3GPP TSG_CN#7
ETSI SMG3 Plenary Meeting #7,
Madrid, Spain
13th – 15th March 2000

NP-000075

Agenda item: 5.2.3
Source: TSG_N WG2
Title: CRs to 3G Work Item Pre paging

Correction of the SDL diagrams for Pre-paging

Figure 54h: Process PRN_VLR (sheet 8)

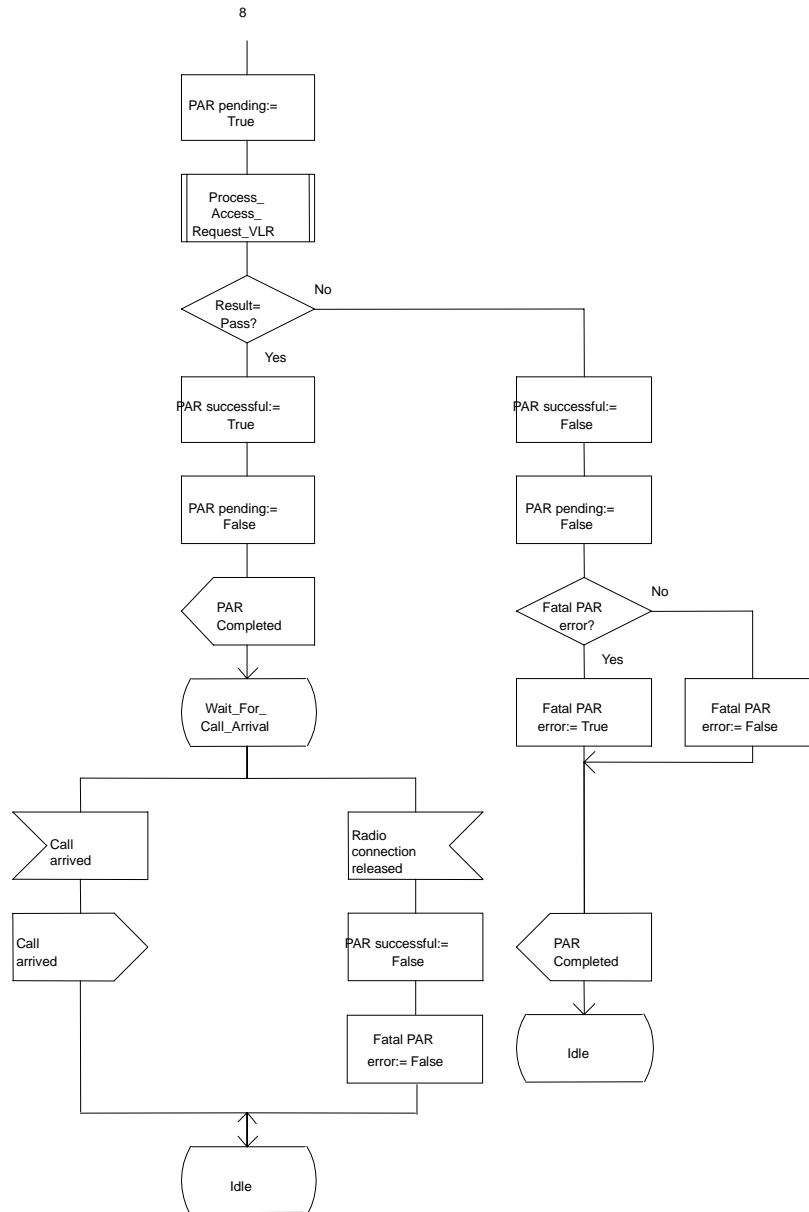
In the retrieval of routing information for a MT call, VLR receives a Provide Roaming Number message from the HLR. If the VLR is practicable the Pre-paging, the VLR initiates a paging procedure.

When the timer for release of radio resources in the MSC expires before the MSC receives the IAM, the MSC send a "Radio connection release" message to the VLR.

When the VLR receives a "Radio connection release" message from the MSC, the VLR set the "PAR successful := False".

In this point, the description that the VLR set "Fatal PAR error := False" is missing in the 3G TS 23.018 specification.

This CR shows the correction of the SDL diagrams.
